| Project Title: | Palmdale Hybrid Power Project - Compliance |
| Document Title: | Palmdale Energy, LLC's Petition for Amendment |

PALMDALE ENERGY PROJECT

**Subject: PALMDALE ENERGY, LLC'S PETITION FOR AMENDMENT
PALMDALE HYBRID POWER PROJECT
DOCKET NO. (08-AFC-9C)**

FIGURE 2-5a ELEVATION LOOKING NORTH

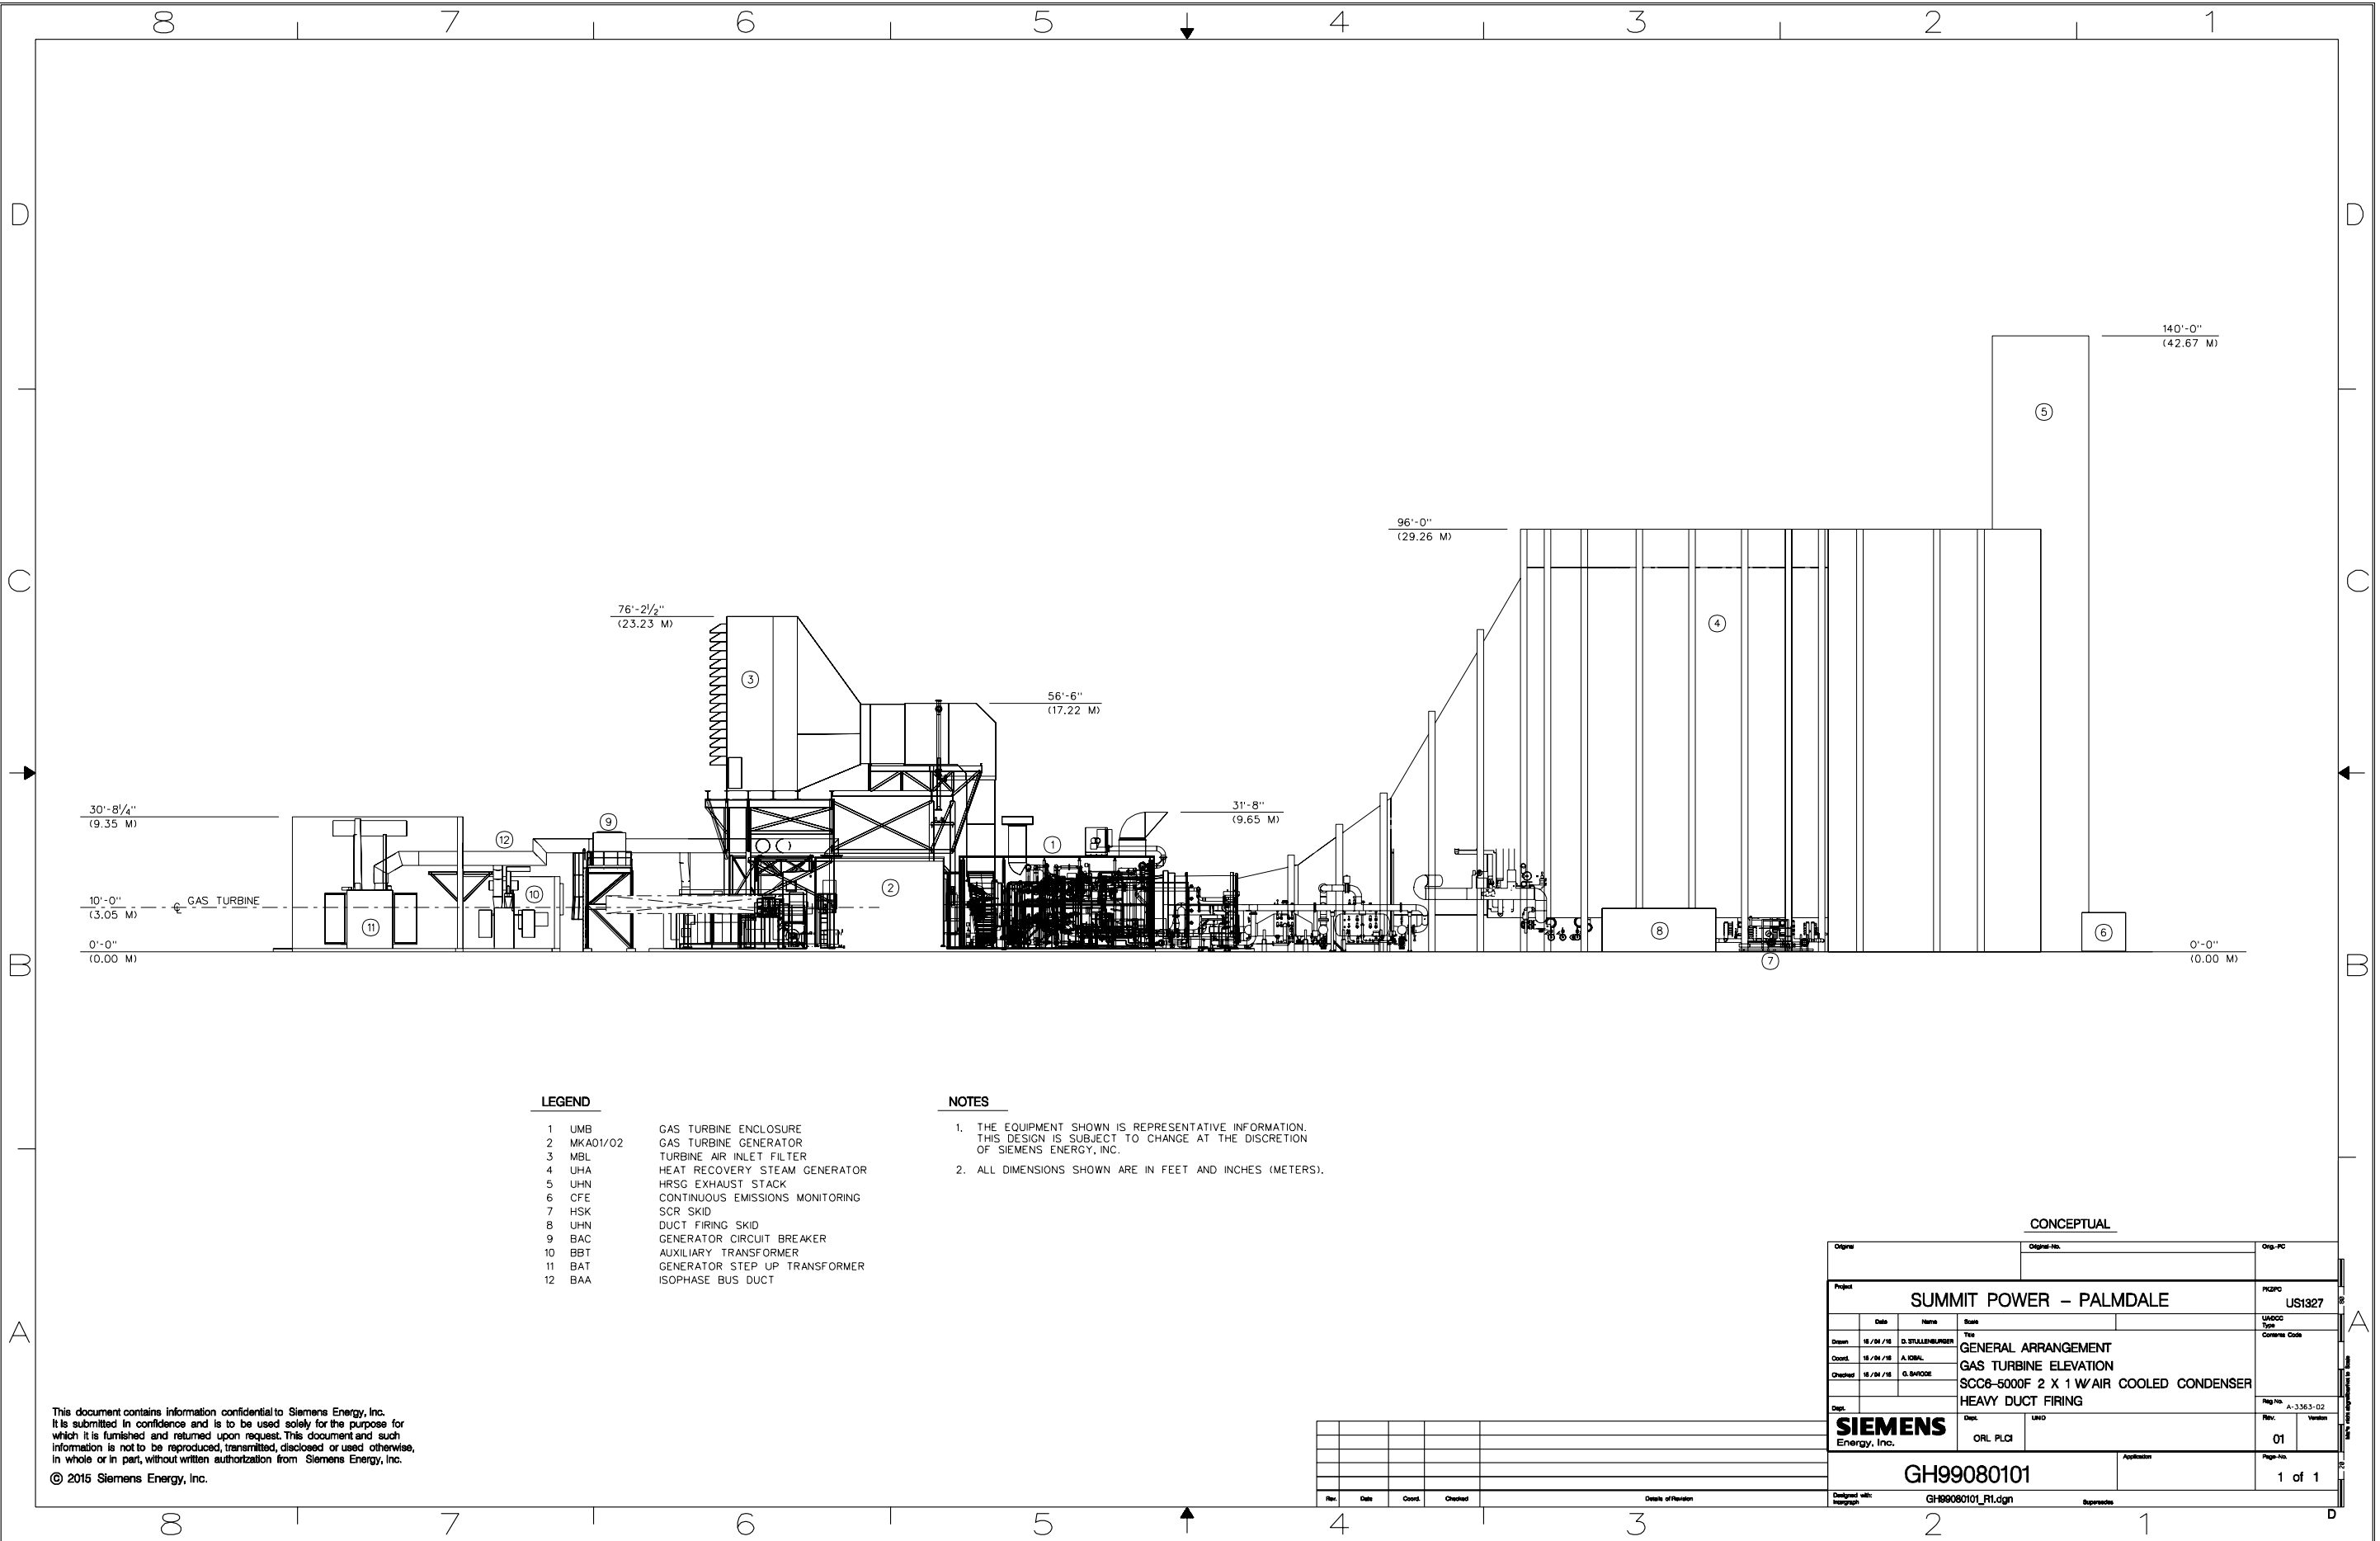
Figure 2-5a is an elevation drawing looking north and Figure 2-5b is an elevation drawing looking west. Equipment dimensions are provided in Appendix 2-A.

FIGURE 2-6a HEAT BALANCE DIAGRAM

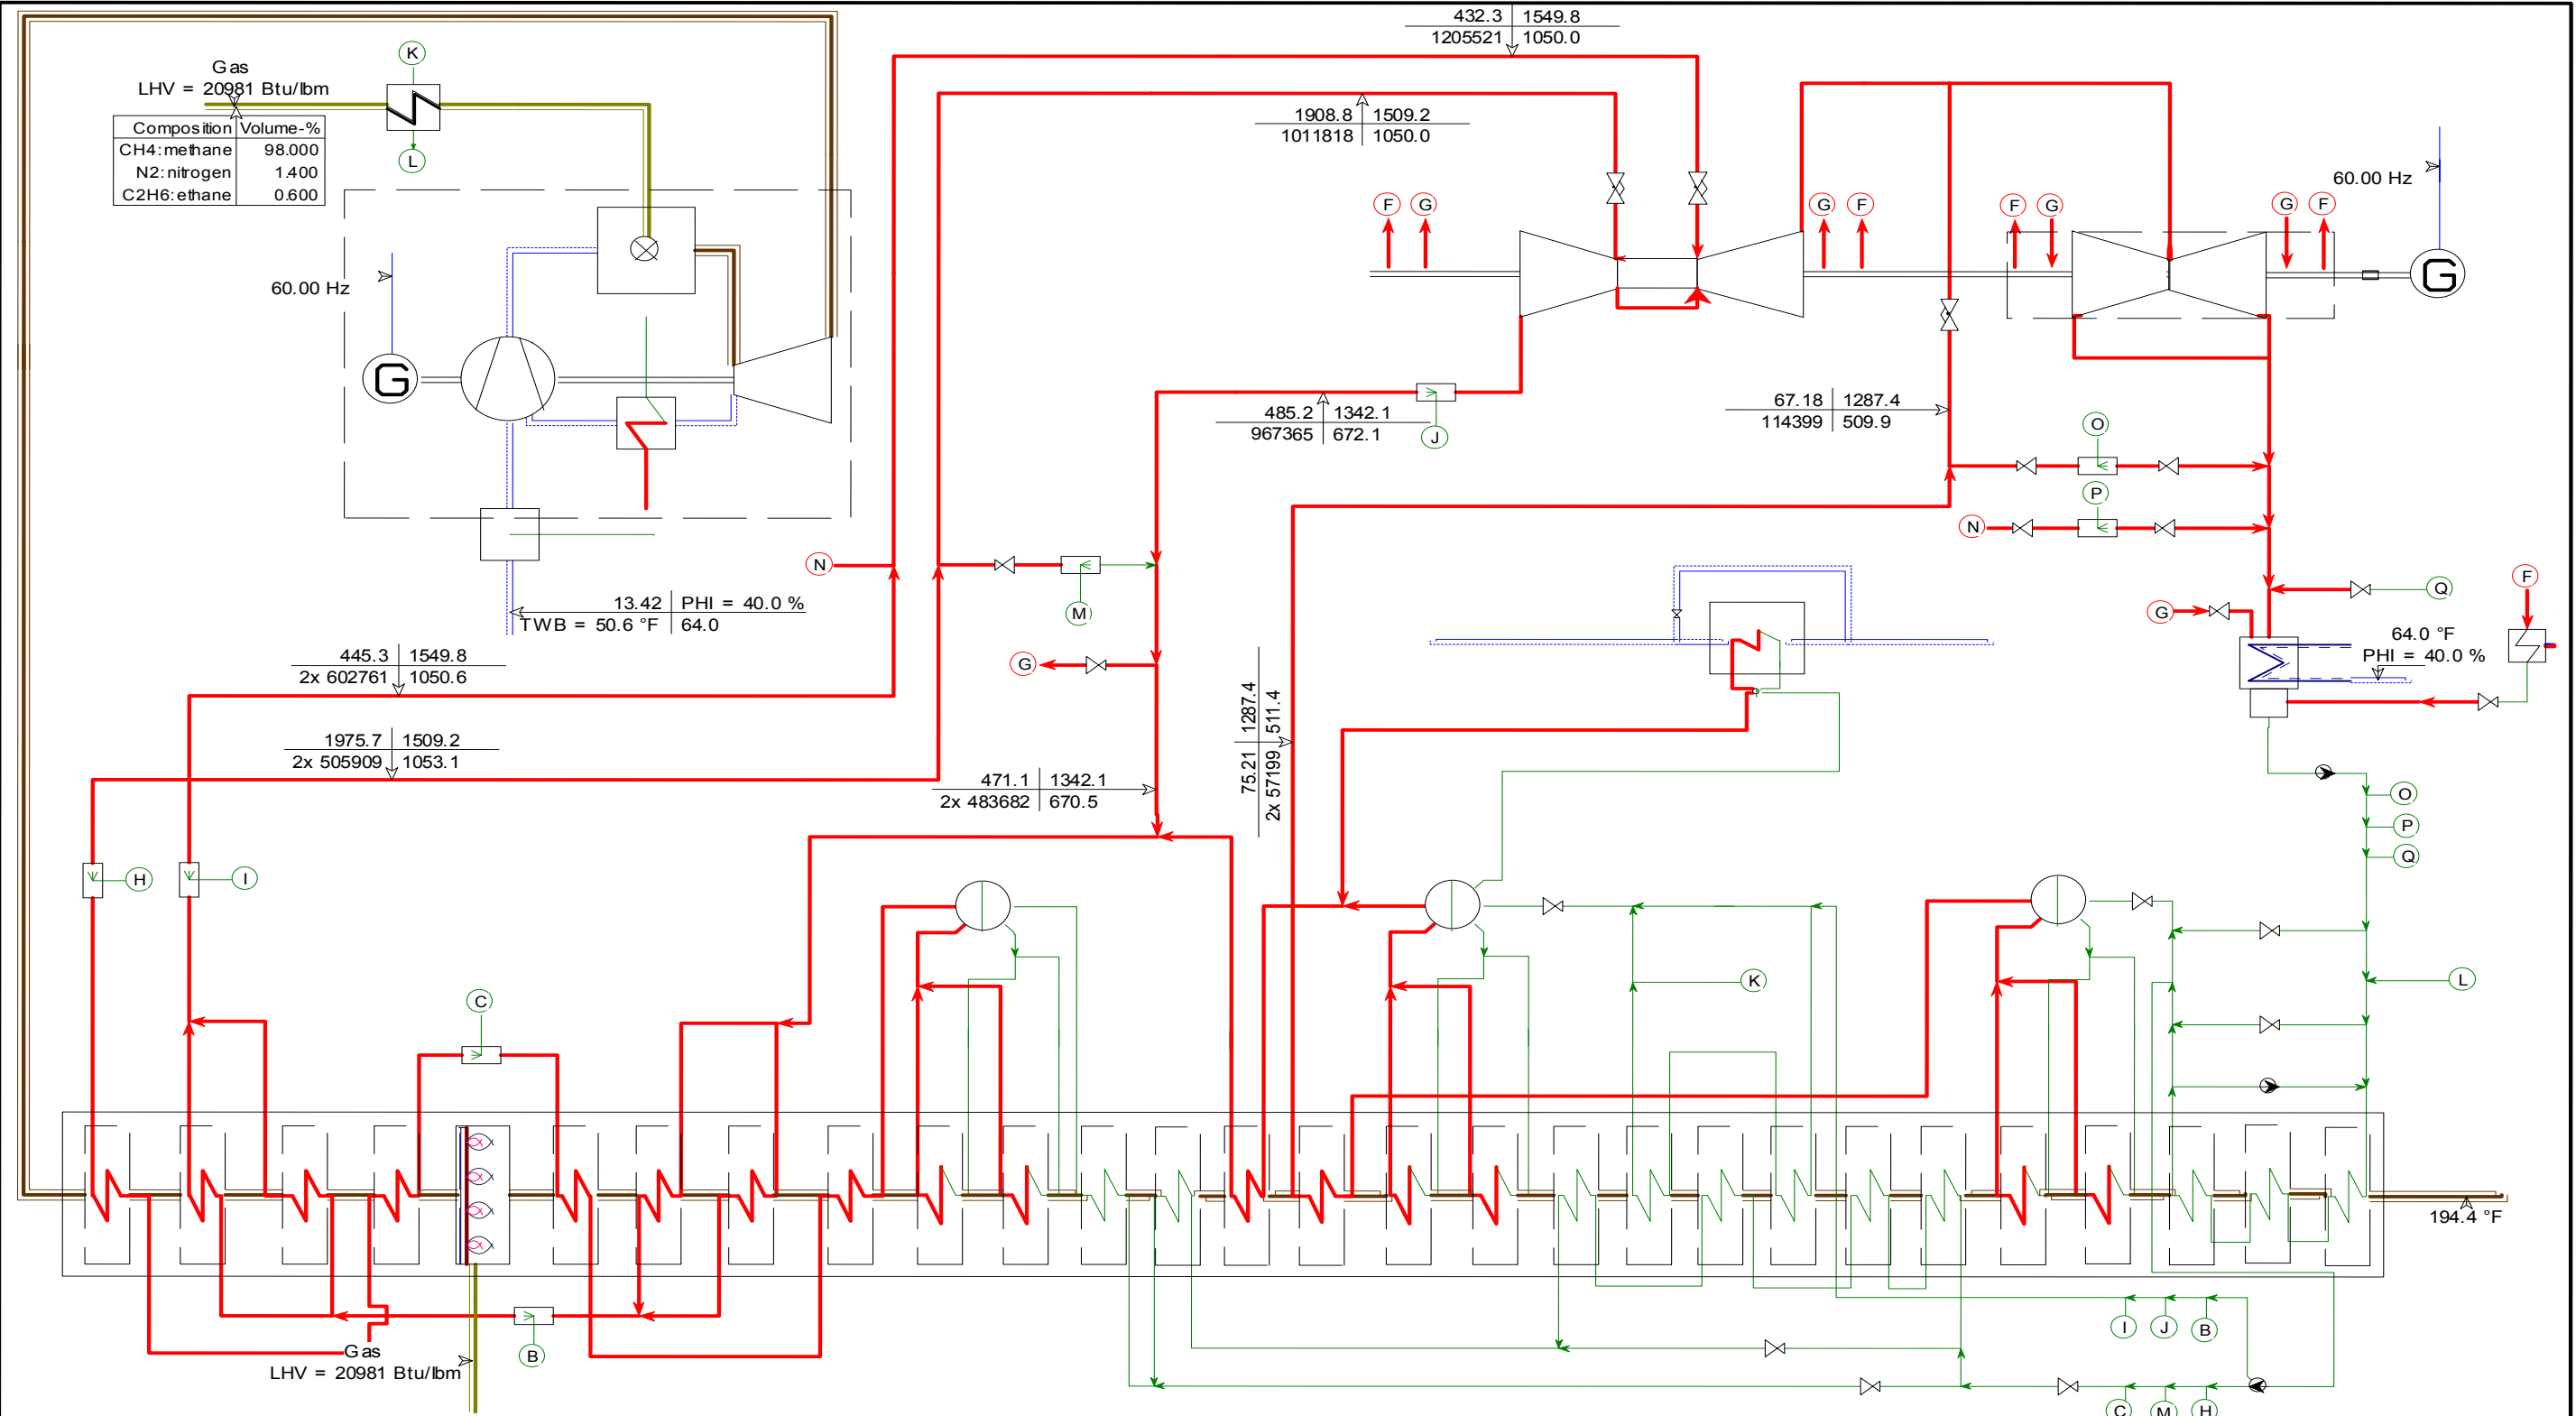
A heat balance diagram corresponding to base load operation of the PEP is shown in Figure 2-6a. This base load heat balance is based on average ambient conditions of 64°F/40% relative humidity, evaporative coolers in-service, and duct burners out-of-service. A heat balance at the same conditions but with the evaporative coolers in-service is provided as Figure 2-6b. A heat balance diagram corresponding to peak load operation of the facility is shown in Figure 2-6c. This peak load heat balance is based on the same average ambient conditions as the base load heat balance, with evaporative

FIGURE 3-1a SINGLE-LINE DIAGRAM, SWITCHYARD

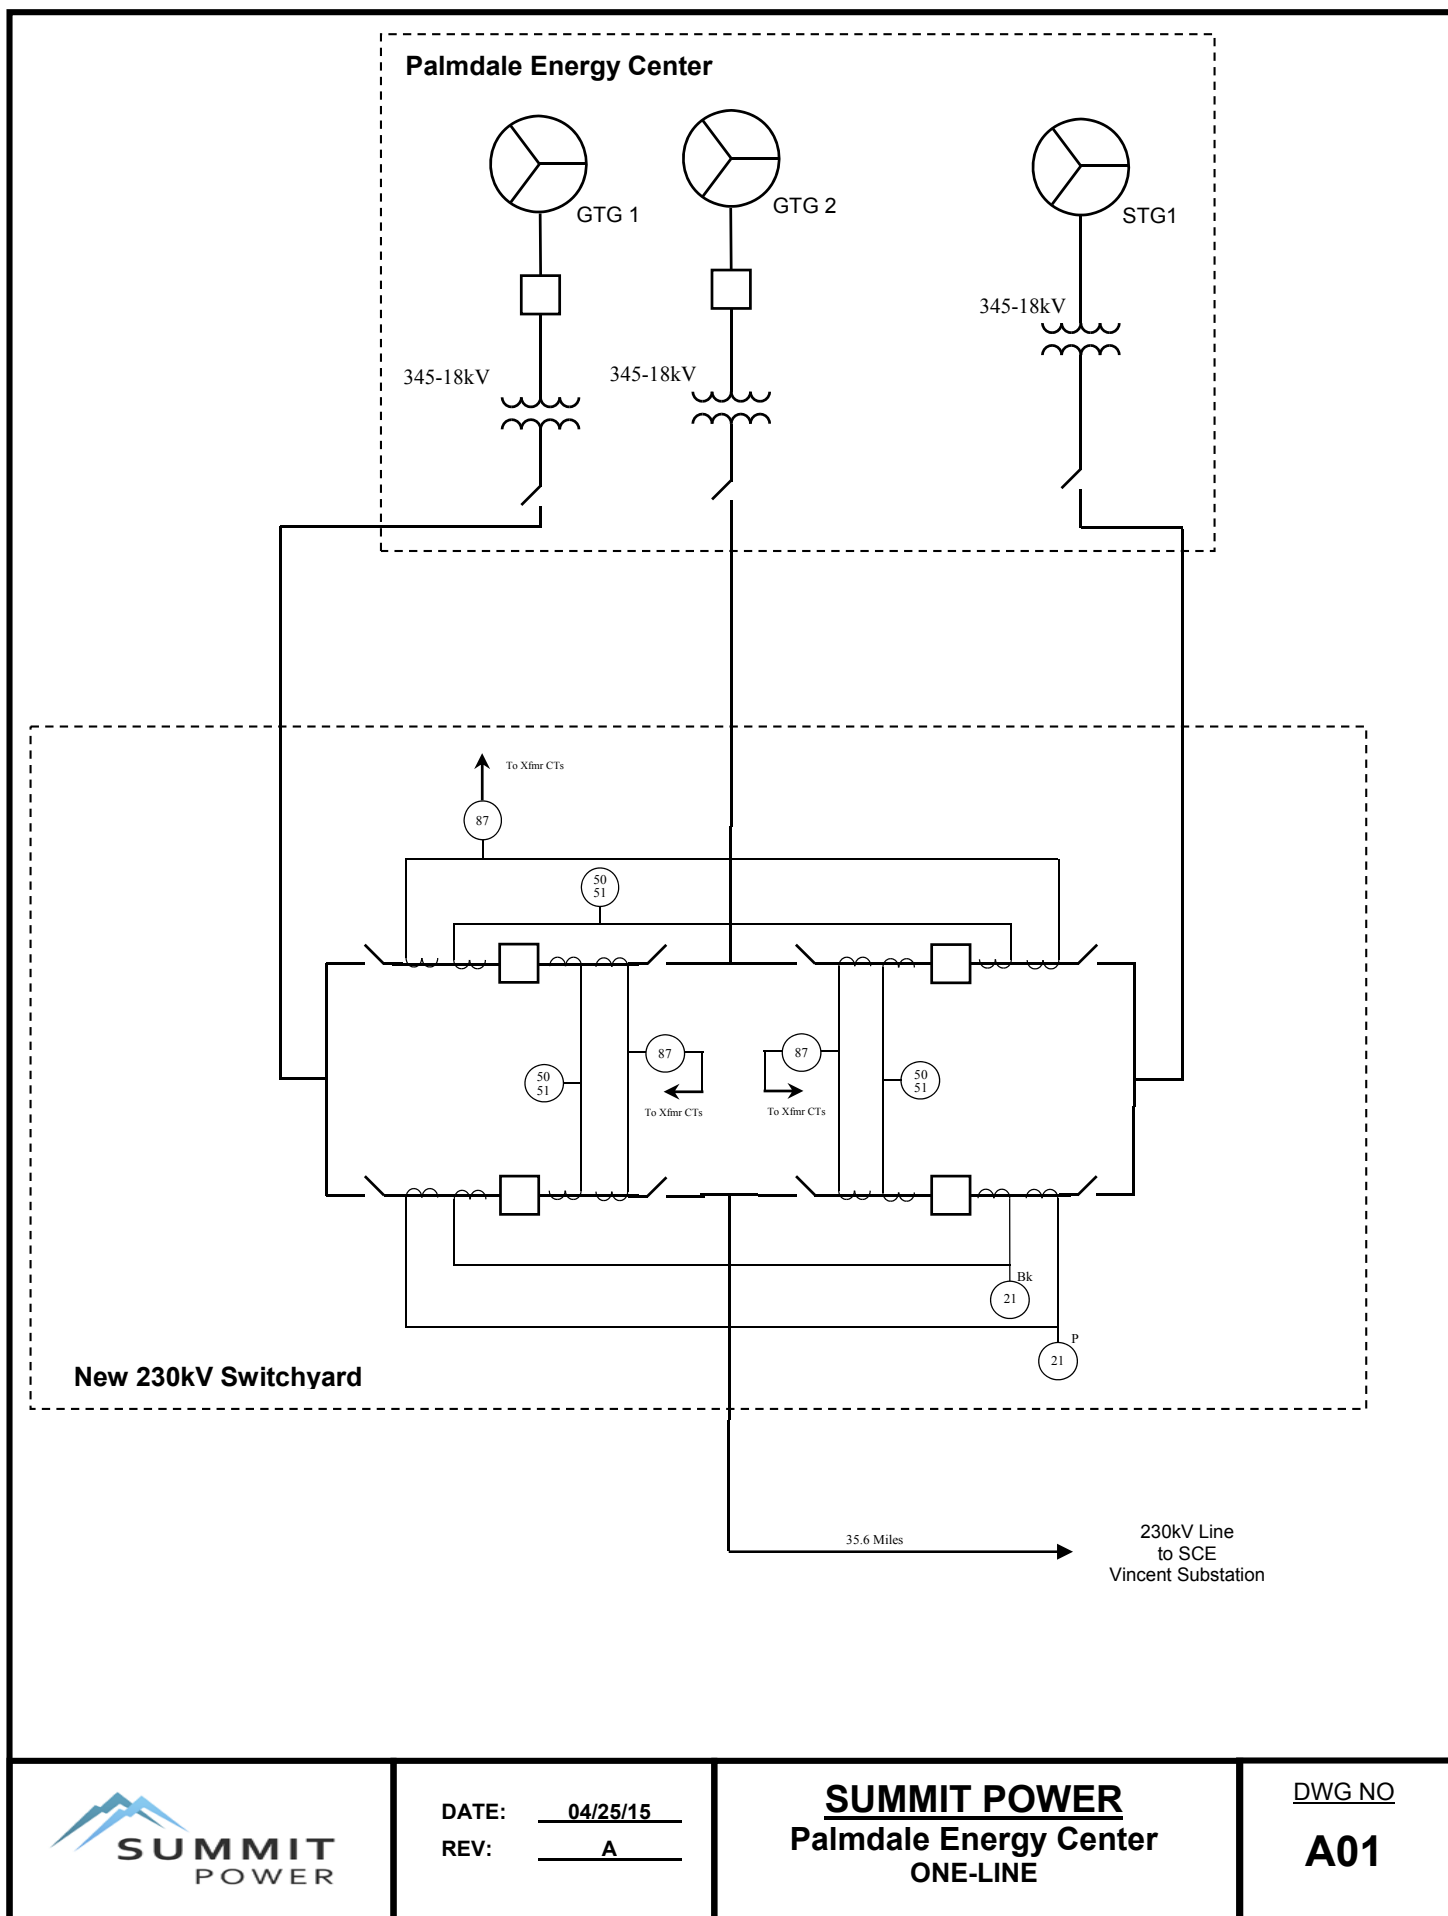
Since the Modified Project is replacing the generation equipment, new preliminary single line diagrams are provided at this end of Section 3 of this Petition. Figure 3.1a shows the single-line diagram for the new project switchyard and Figure 3.1b shows a single-line diagram for the power block.
